South Texas Project
Units 3 and 4
Docket Nos. 52-012 and 52-013
Supplemental Response to Request for Additional Information

RAI 02.05.02-19, Supplement 2:**SUPPLEMENTAL QUESTION:**

RAI 02.05.04-33**QUESTION:**

Figure 2.5S.2-39 Logarithmic Mean and Standard Deviation of Site Amplification Factors Transfer Functions (Amplification Factors) at Ground Surface from Analysis of the 60 Modified Random Profiles with the 10^{-4} LF Input Motion

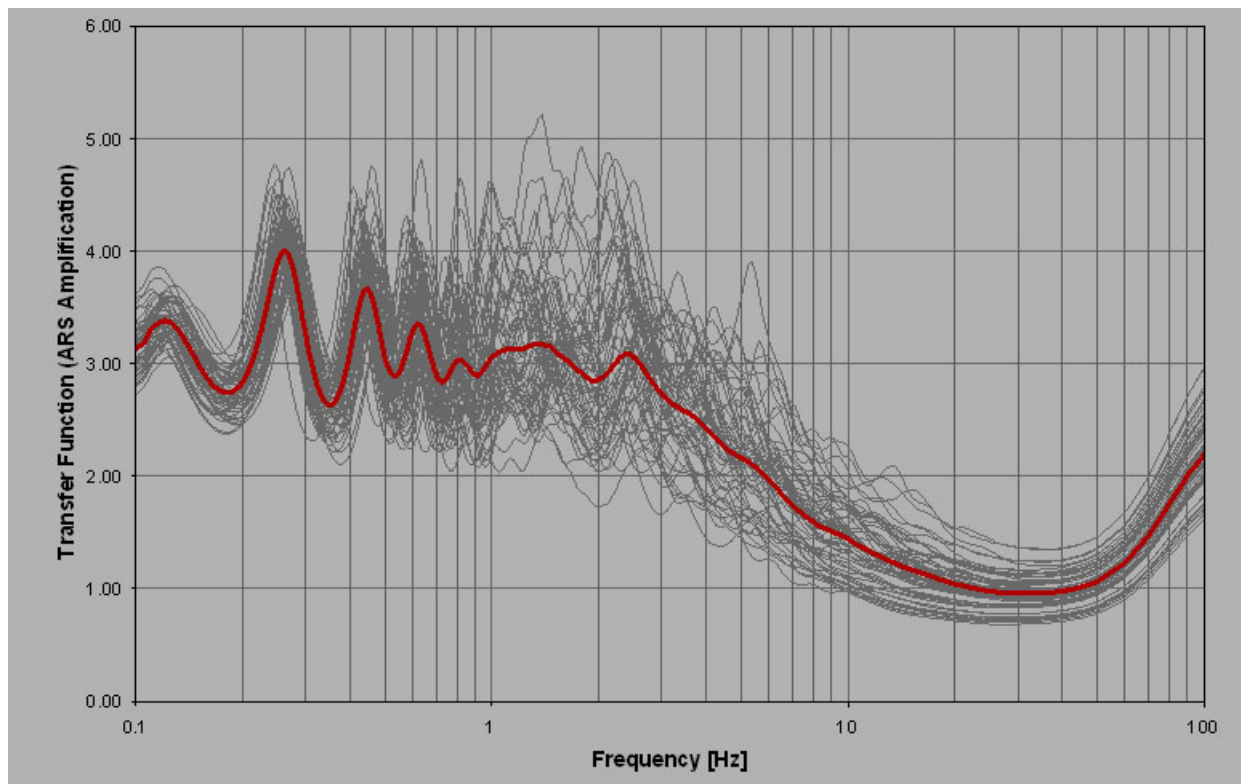
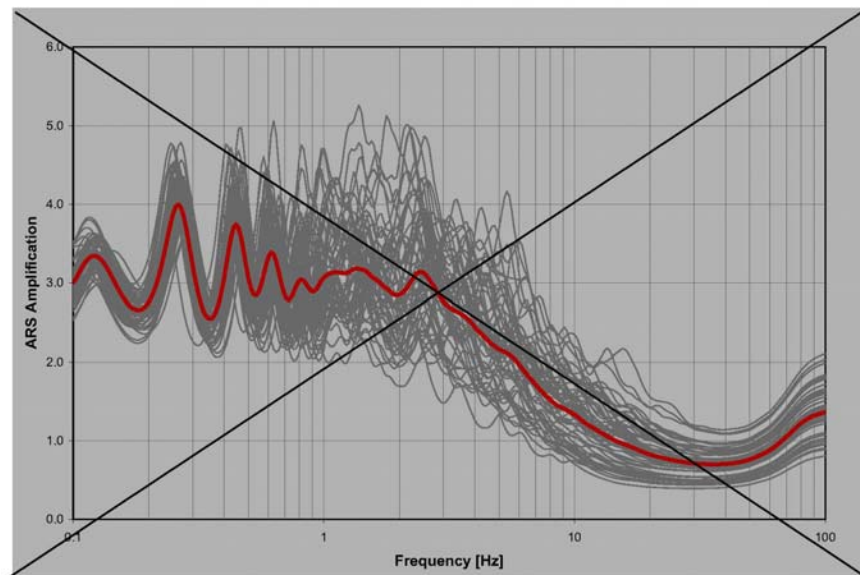
During a telephone conference with the NRC Staff on November 12, 2009, STPNOC agreed to provide supplemental information to clarify the changes to FSAR Tables 2.5S.2-18 and 2.5S.2-19 provided in STP COLA Revision 3 and to explain the differences between these tables and Figures 2.5S.2-39, 2.5S.2-41, 2.5S.2-43, 2.5S.2-45 and 2.5S.2-49a. These Tables and Figures were shown as replaced in their entirety in Supplement 1 to the response to RAI 02.05.02-19 (STP Letter U7-C-STP-NRC-090090 (ML 092250658) dated August 10, 2009). Revision 3 of the FSAR incorporated the changes submitted in RAI 02.05.02-19.

- a- new material parameters from newly available Resonant Shear Column Torsional (RCTS) test data;
 - b- deep sonic log data that resulted in changes in deep velocity profile; and
 - c- a truncation study that resulted in the soil column model being extended deeper.
- 2) During this review, STPNOC identified that FSAR Figures 2.5S.2-39, 2.5S.2-41, 2.5S.2-43, 2.5S.2-45 and 2.5S.2-49a should be revised to show the transfer functions consistent with the revised values in Tables 2.5S.2-18 and 2.5S.2-19.

FSAR Figures 2.5S.2-39, 2.5S.2-41, 2.5S.2-43, 2.5S.2-45 and 2.5S.2-49a will be replaced as shown on the following pages:
